ADDENDUM DATE: December 14, 2023

ADDENDUM NO. 4

Cobblestone Manor
1050 Lamplighter Drive
Grove City, Ohio 43123

Addendum No. 4 to the Drawings and Project Manual, dated June 8, 2023, Cobblestone Manor as prepared by Moody Nolan, Inc., 300 Spruce St. Suite 300, Columbus, OH 43215.

DRAWING TITLE:
**LEVEL 01 - FLOOR PLAN -
POWER - AREA A**

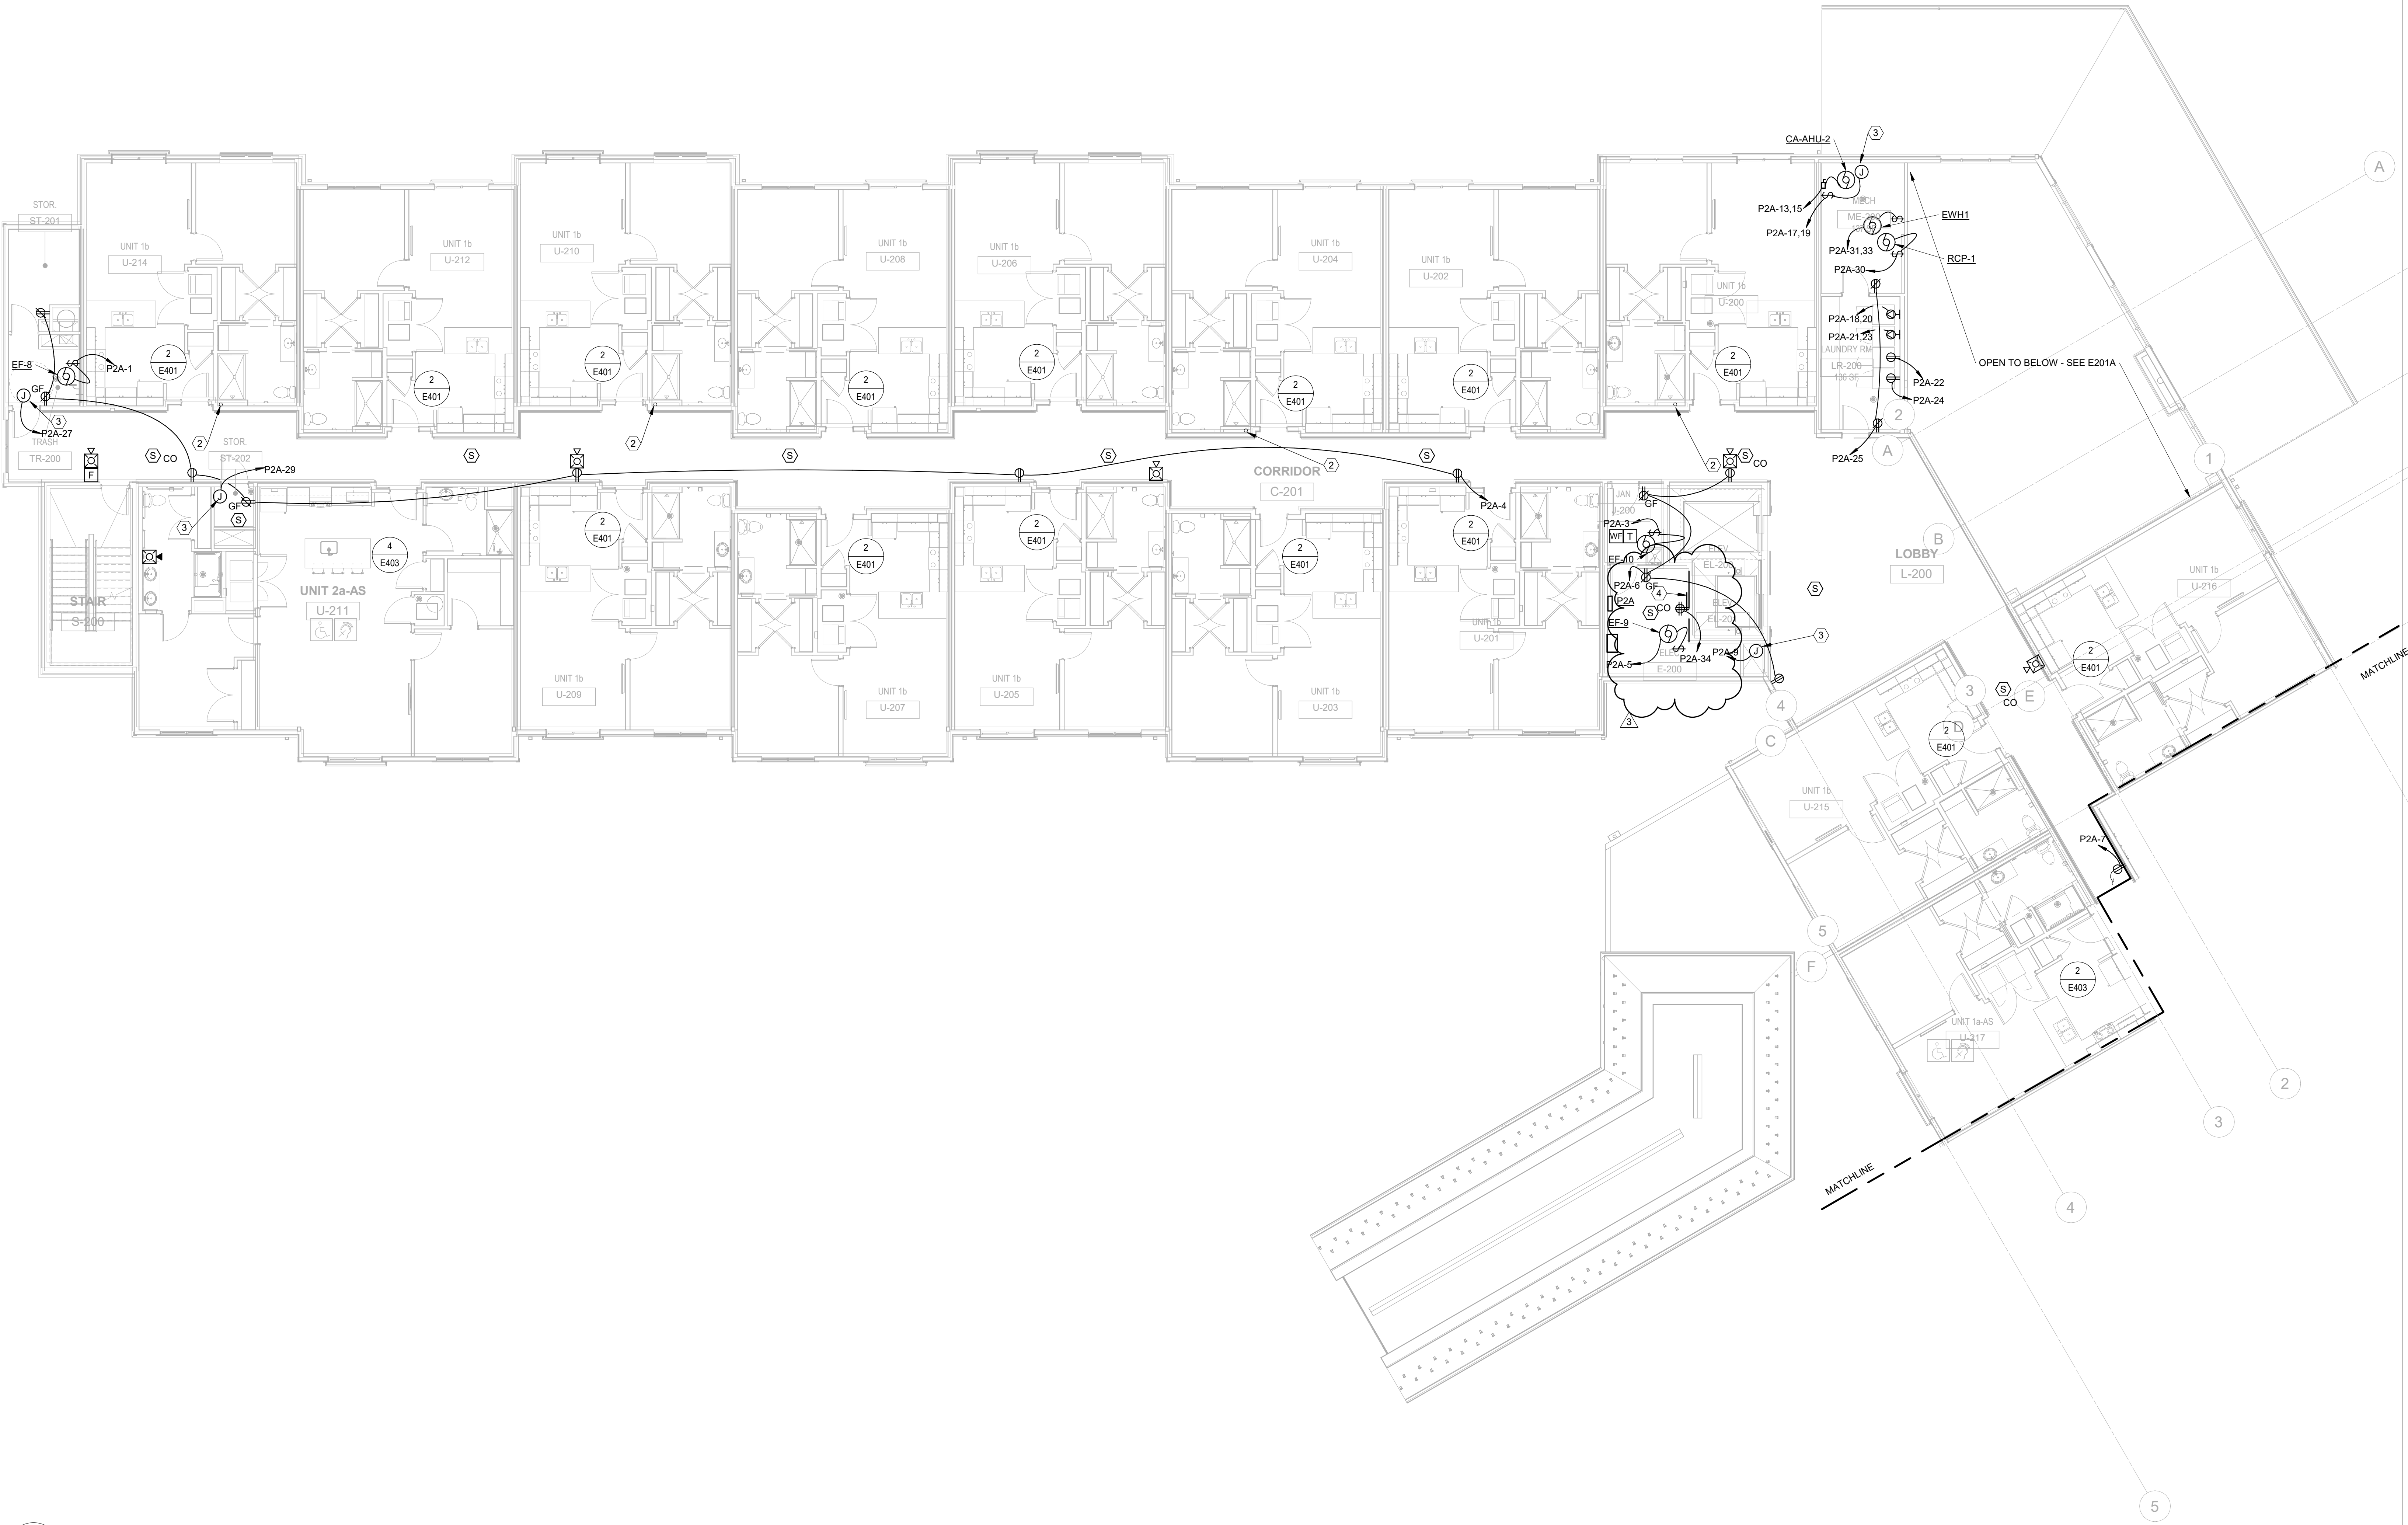
a. E201A – LEVEL 01 – FLOOR PLAN – POWER – AREA A

1. **REVISE** note about telecom demark to include fire rated floor penetrations.

- TELECOM BACKBOARD, GROUND BAR, AND DEMARC LOCATION. PROVIDE 2-4" FIRE RATED PENETRATIONS TO FLOOR ABOVE.
 - FIRE ALARM DEVICES SERVING FIRE WATER SERVICE ENTRANCE AND FLOOR CONTROL VALVE. COORDINATE INSTALLATION WITH FIRE PROTECTION CONTRACTOR AND FIRE PROTECTION DETAILS SHEET F501.

DRAWING TITLE:
**LEVEL 03 - FLOOR PLAN -
POWER - AREA A**

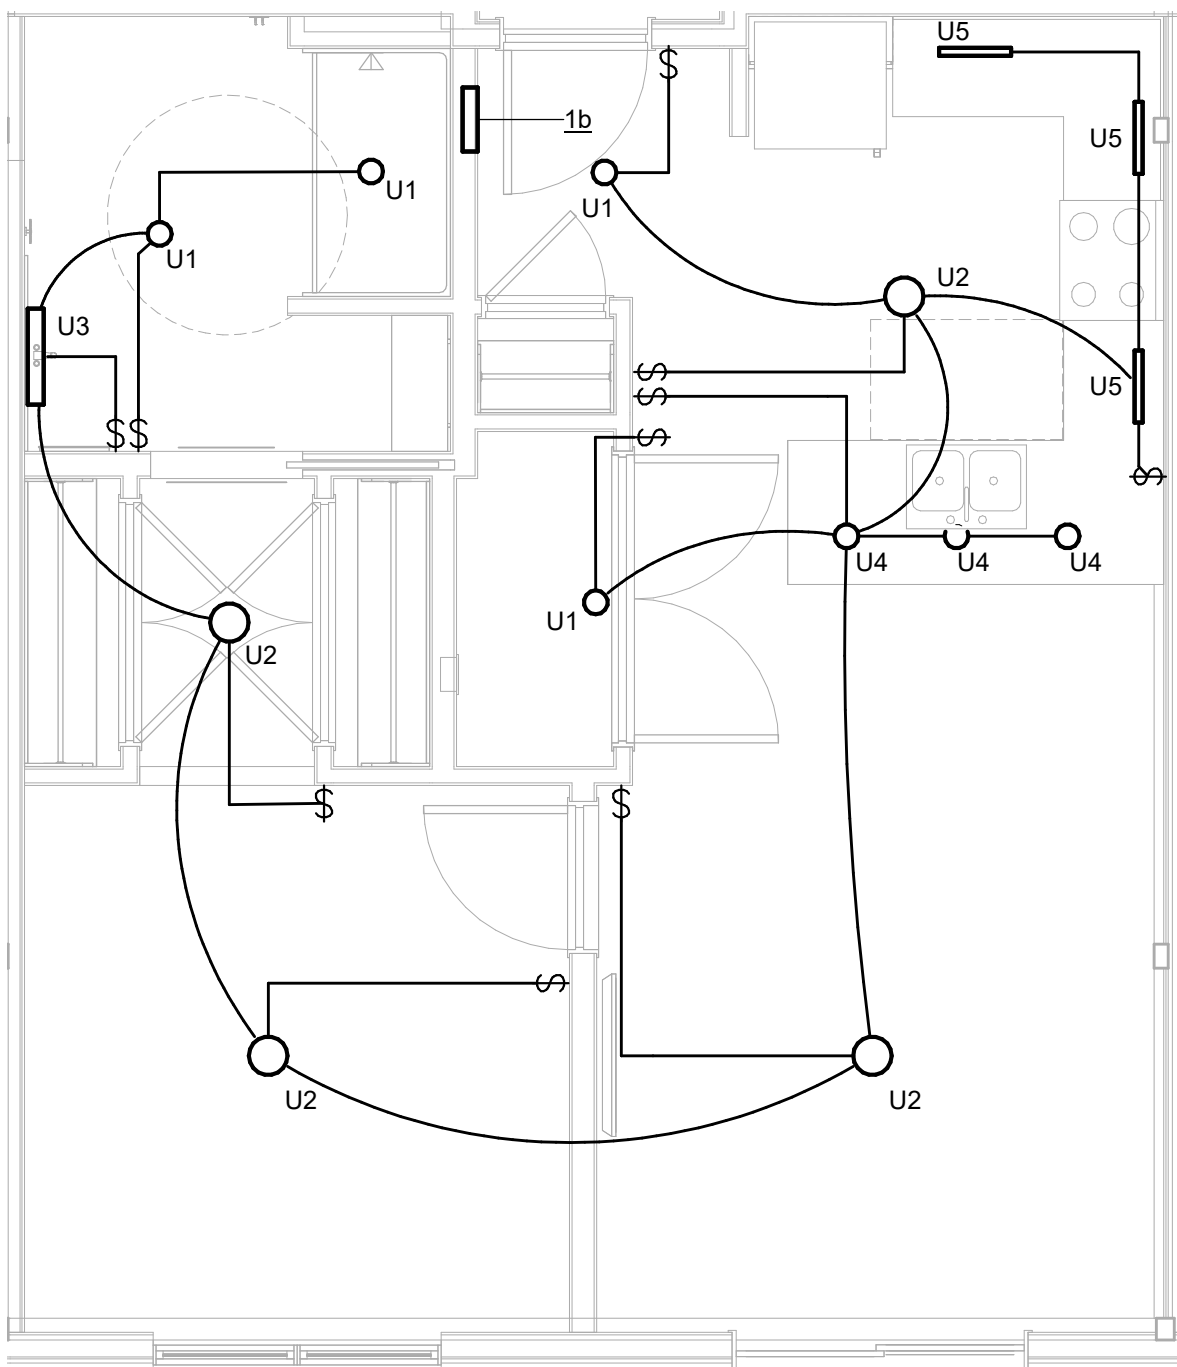
c. E203A – LEVEL 03 – FLOOR PLAN – POWER – AREA A

1. **ADD** telecom demark location and keynote explaining scope.
